SERVICE BULLETIN: JSB 012-8

Issue: 8

Date: 6th January 2021

Subject: Jabiru Engine Flywheel Attachment

Figure 2 - Plain washers compared to Nordloc washers

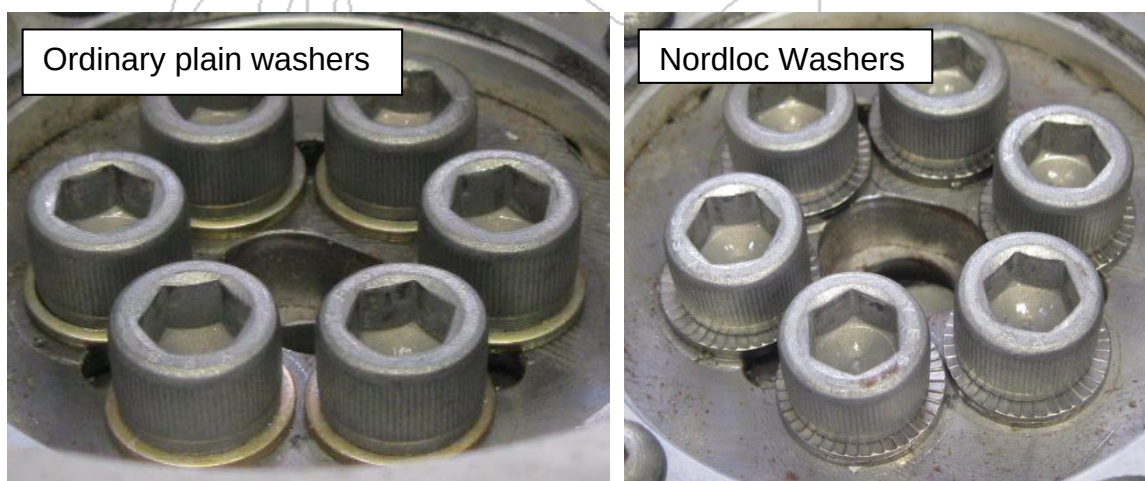
Flywheel screws must now be installed using Nordloc washers (replacing the previous installation which used either plain or Belleville washers). Jabiru engines of any and all flywheel configurations (as defined in Table 1) should now use Nordloc washers. These washers are easily identified via visual inspection as shown below in Figure 2.

Refer to the Jabiru Engine overhaul manual JEM0001 (always check for the latest revision) for the installation procedure of flywheel capscrews using Nordloc washers. The major difference in installation is that bolts installed with Nordloc washers **must not be installed with Loctite**. The torque setting is also different for capscrews installed with these washers.

When Nordloc washers are used on an aluminium surface a steel plate must be used to protect the aluminium surface. These are available from Jabiru.
